CONSTRUCTION PLANS
CLARK COUNTY
FROM THE CALIFORNIA/NEVADA STATE LINE TO 2.42 MILES
EAST OF THE JUNCTION WITH ROUTE US 093

PROJECT NEON
DESIGN UNIT S1-07
BRIDGE PACKAGE 5 (H-933N/S)

STATE	PROJECT NO.	COUNTY	DESIGN UNIT	SHEET NO.
NEVADA	NH-STP-015-1(147)	CLARK	S1-07	B-1

AS-BUILT DRAWING

APPROACH SLAB NO. 1

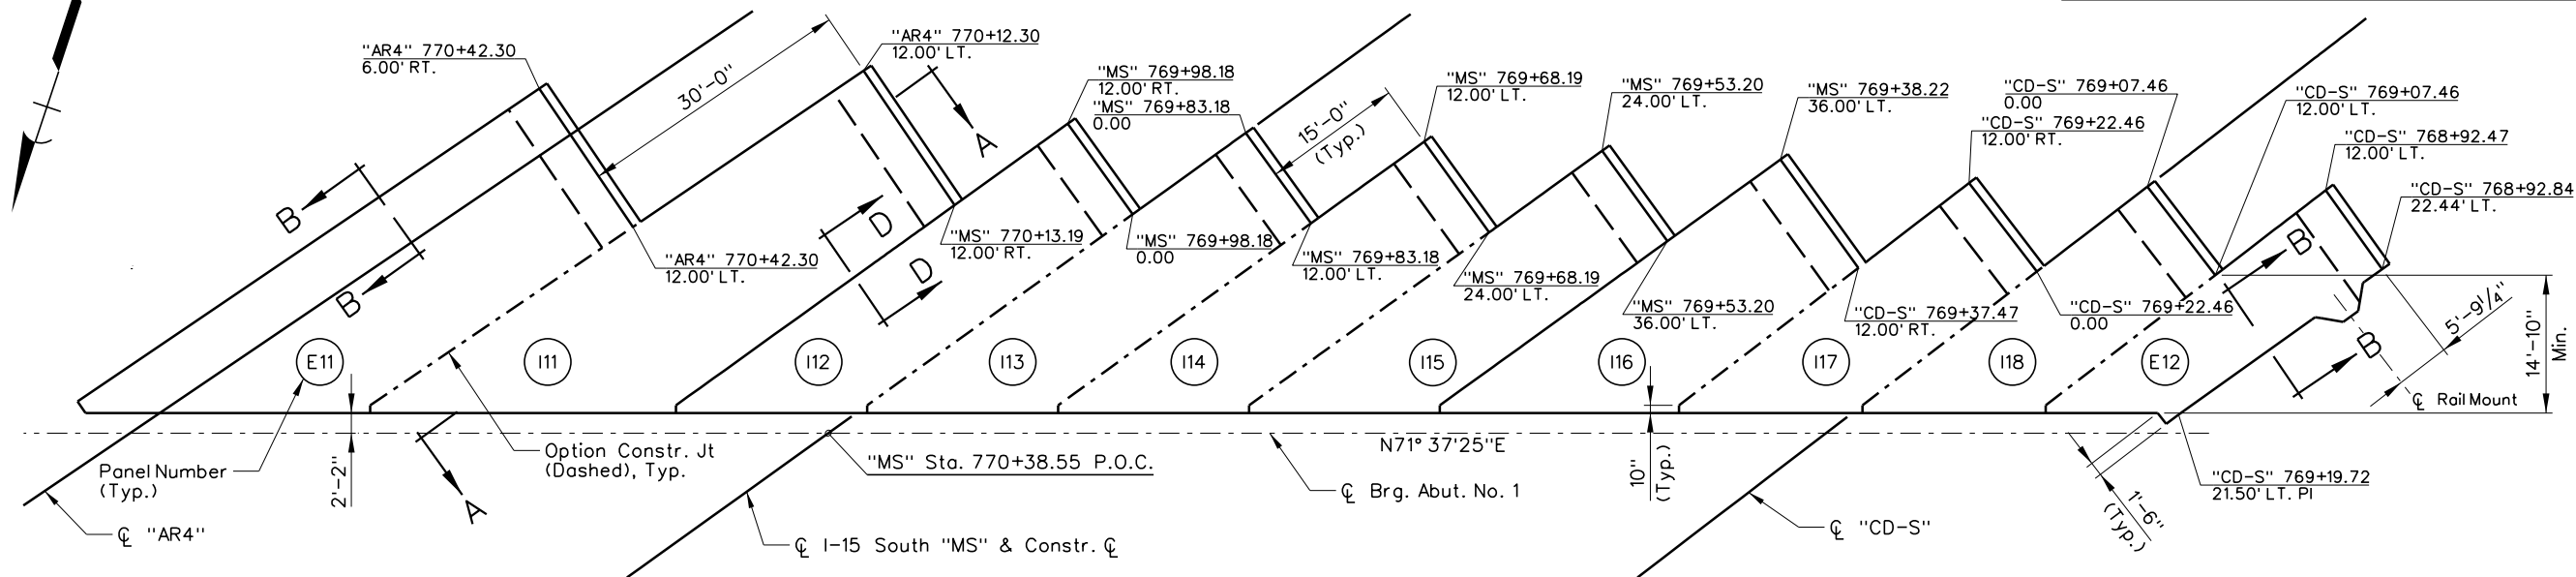
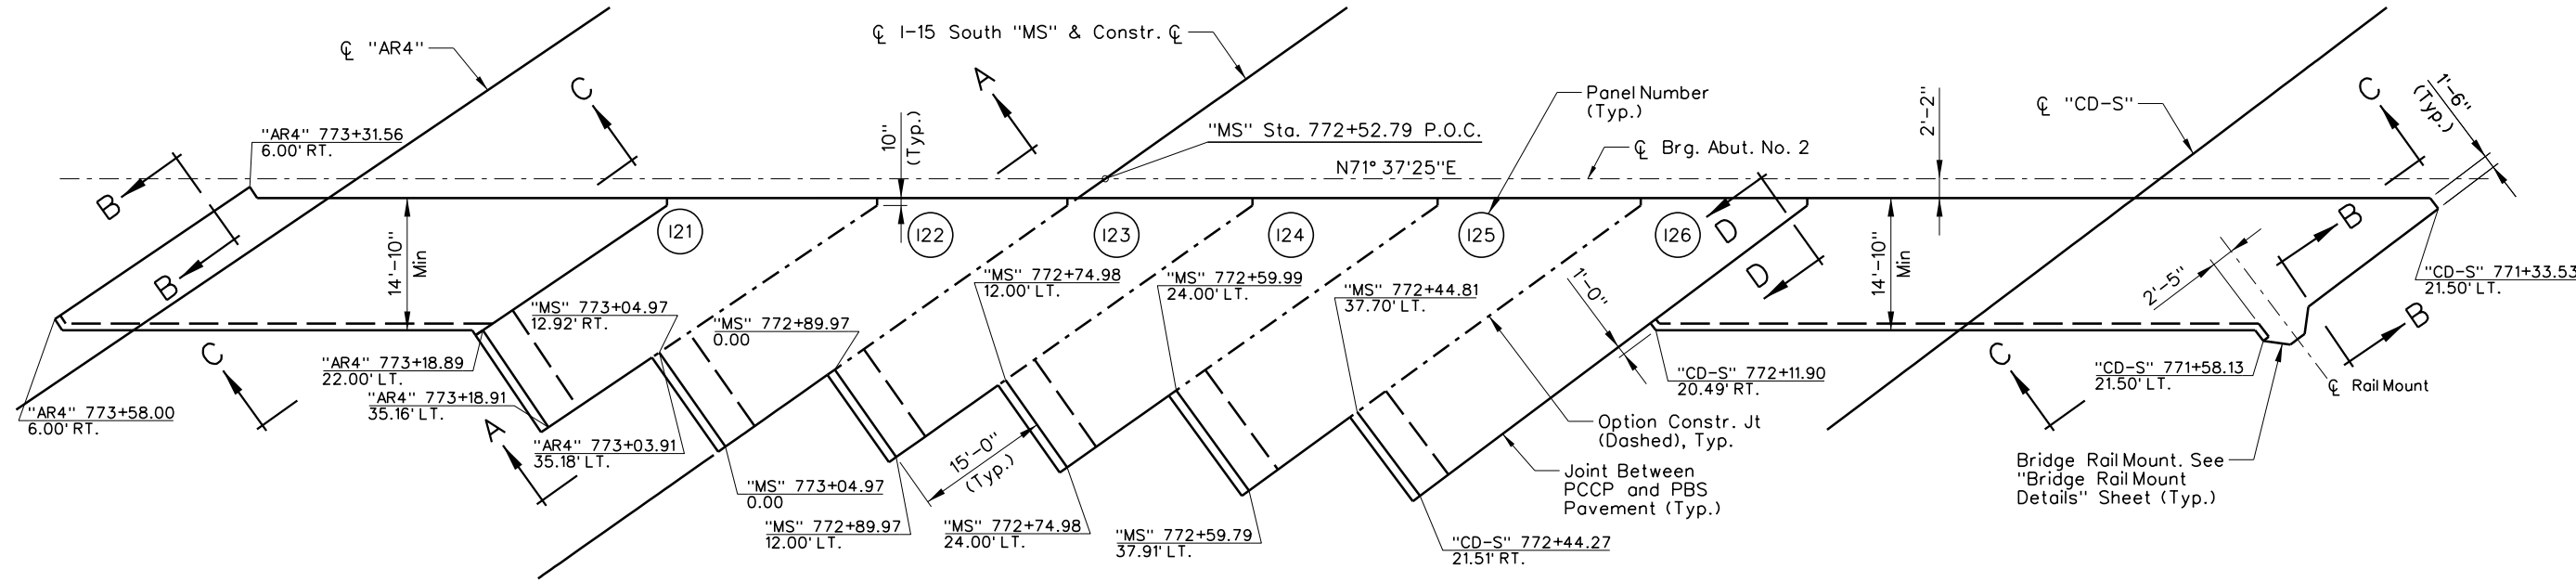
2 NCR 424 - SOME AREAS OF CRACKING IN APPROACH SLAB NO. 1 REPAIRED WITH SIKADUR 55 SLV.

DETAIL A

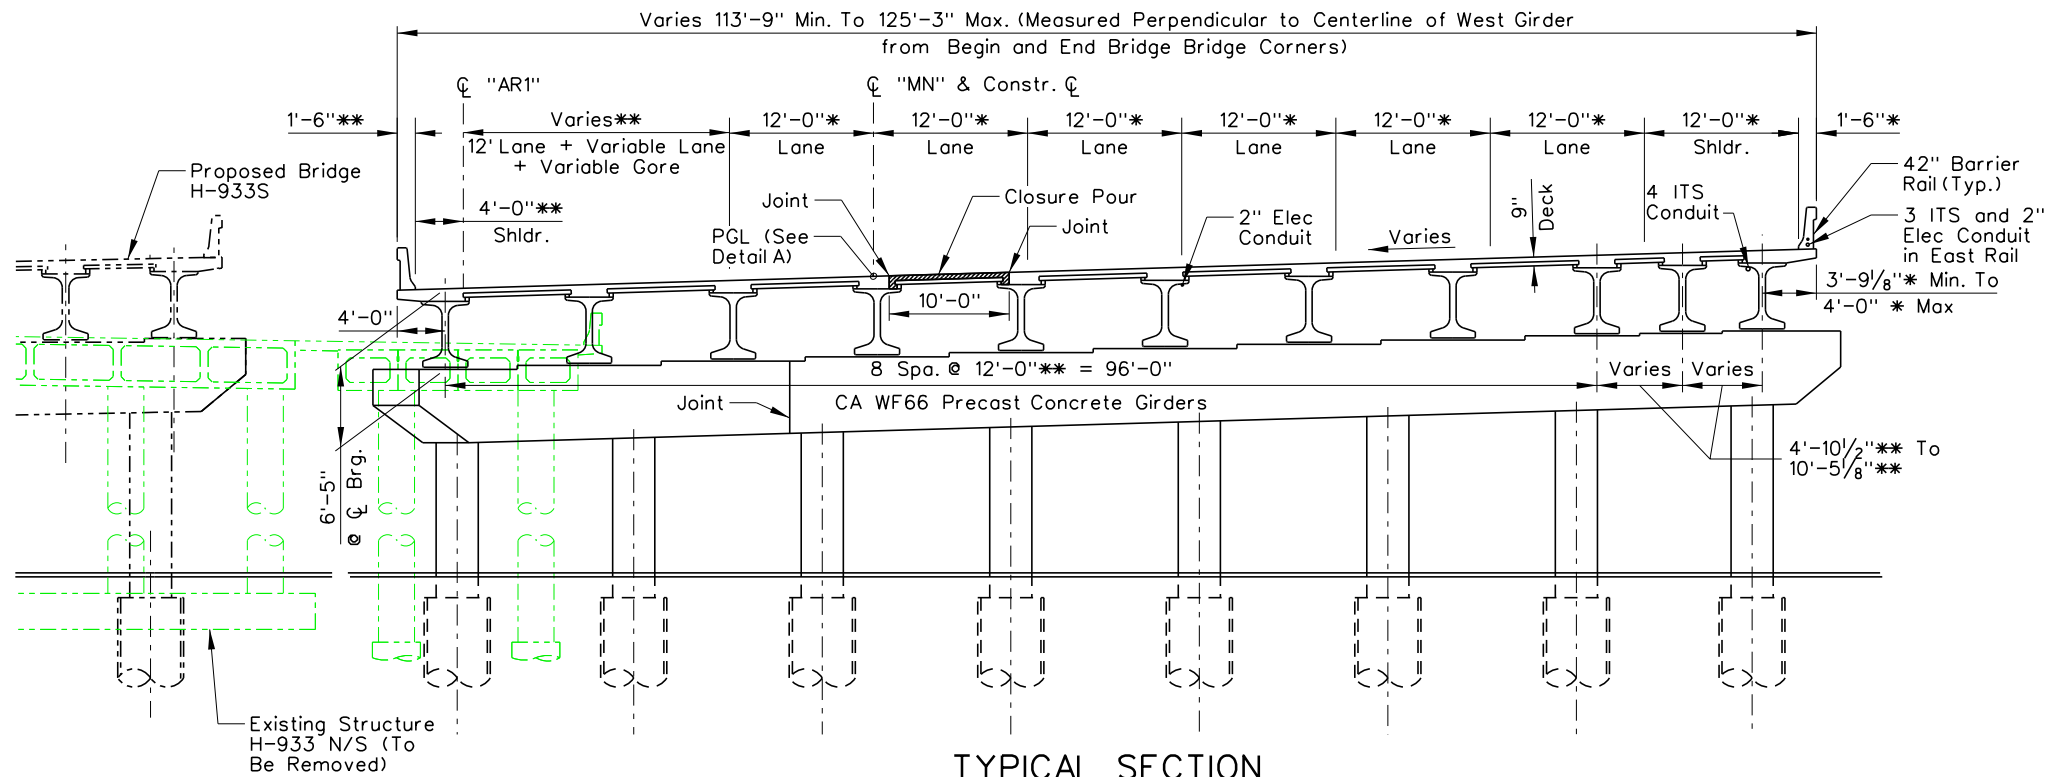
2 NCR 264 - 4\"/>

DRILLED SHAFT ELEVATION

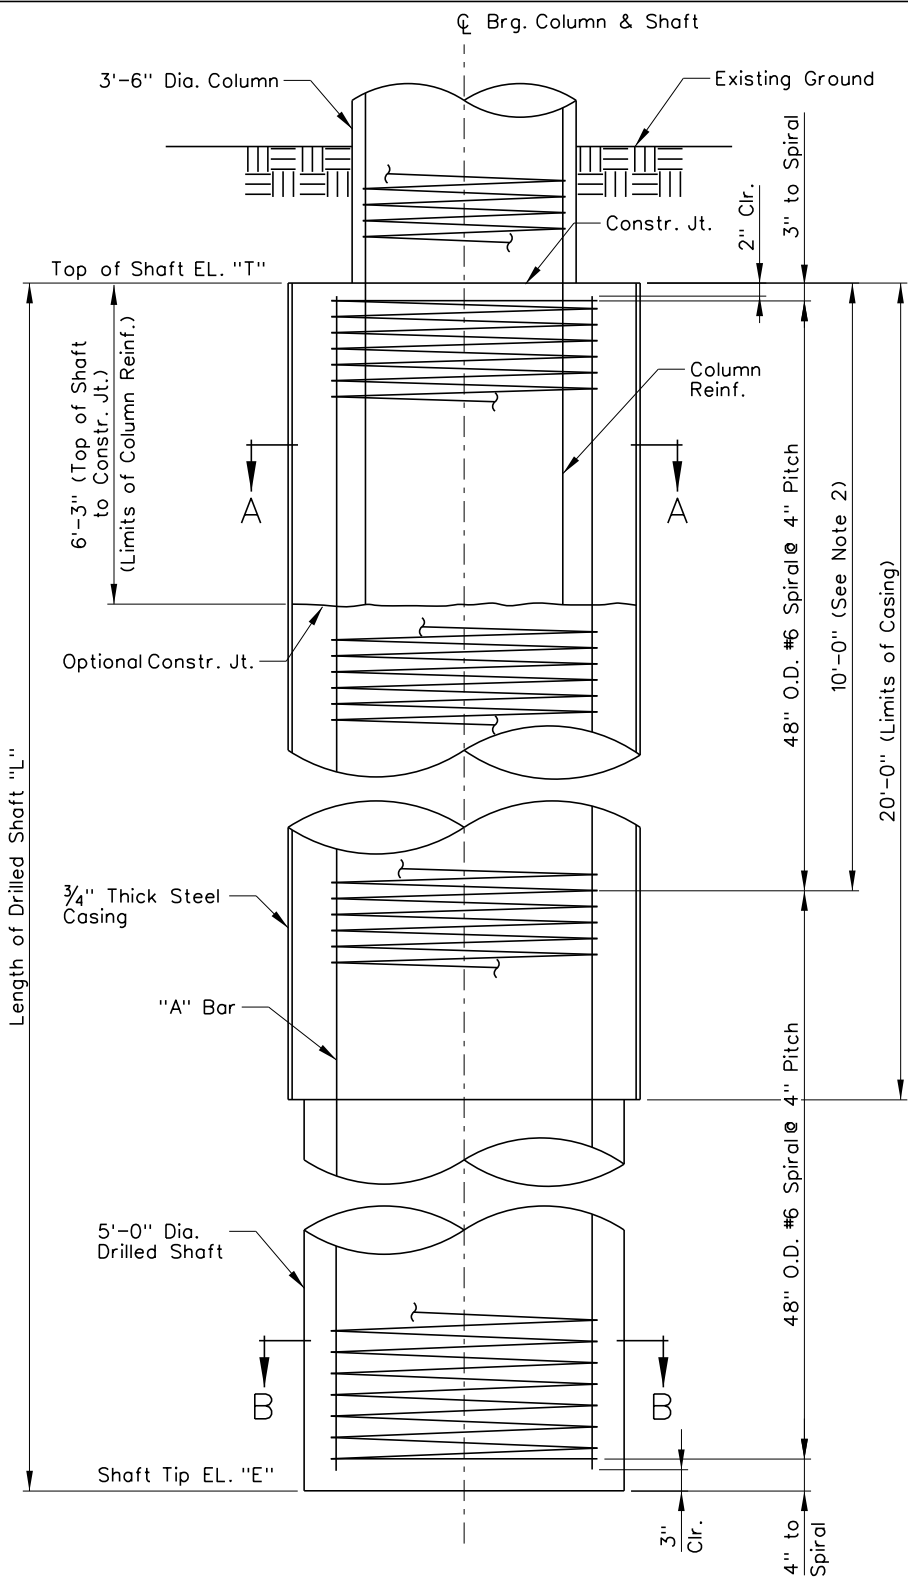
PER NCR 176 - DRILLED SHAFT CAGE #8 IS LOCATED 3" OUT OF PLAN. COLUMN CAGE PLACED PER PLAN WITH REDUCED CLEARANCE TO SHAFT CAGE.

PARTIAL ELEVATION
(Looking Ahead Station)

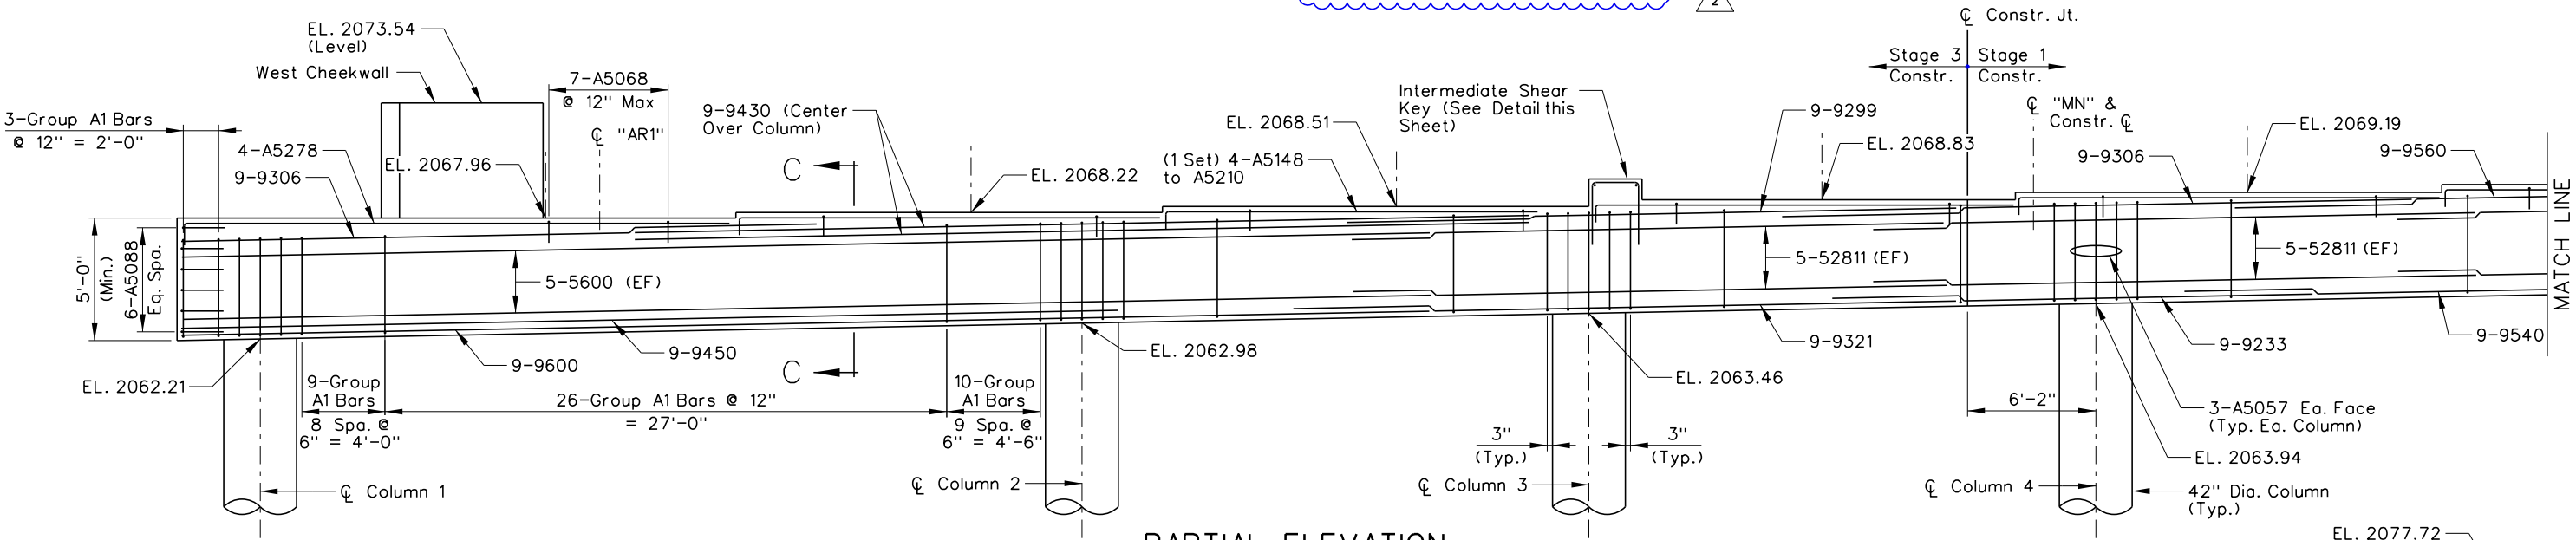
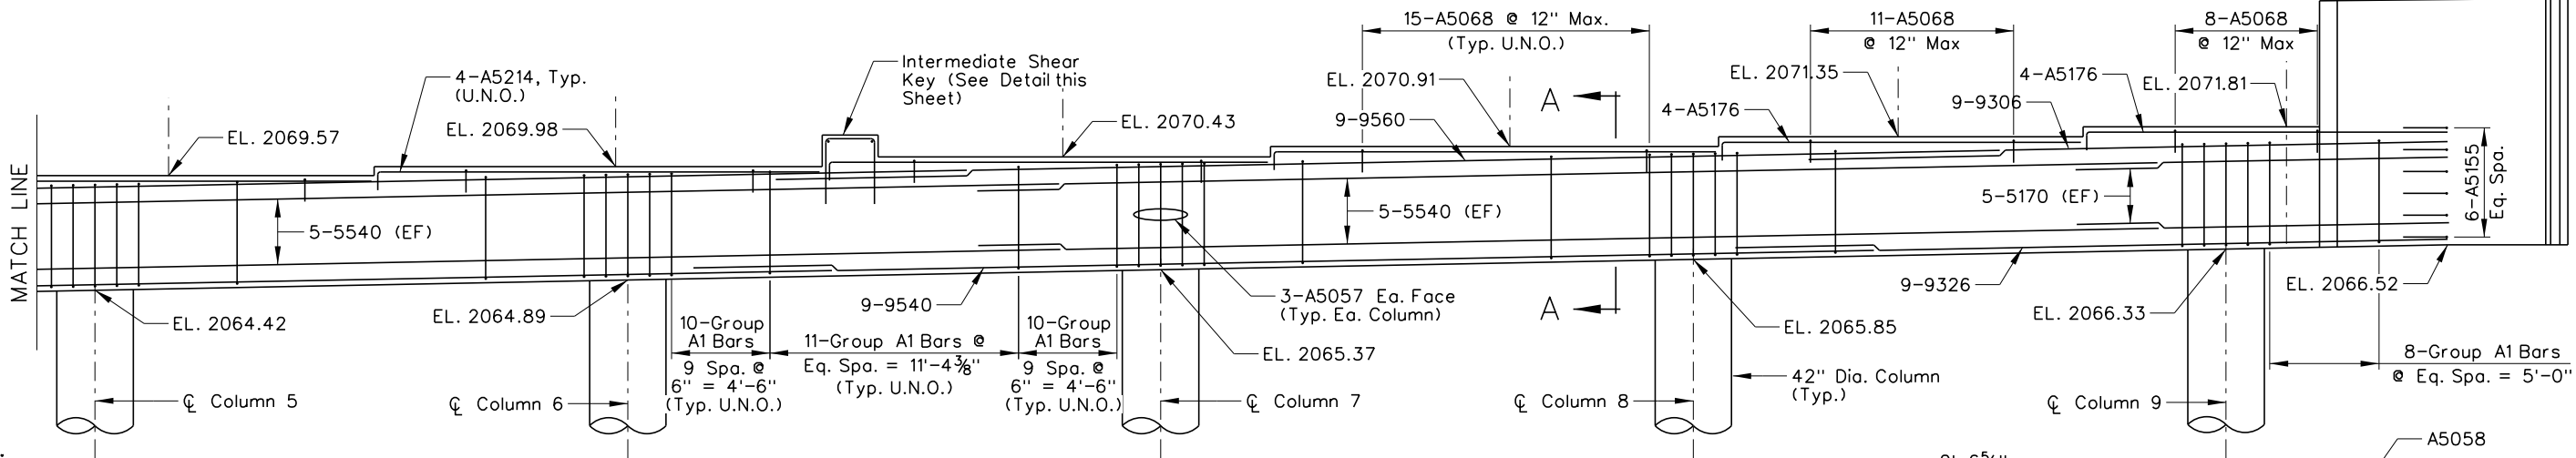
3 NCR 375 - INTERMEDIATE SHEAR KEY BETWEEN GIRDERS 3 AND 4 PLACED TWO FEET TO THE WEST.
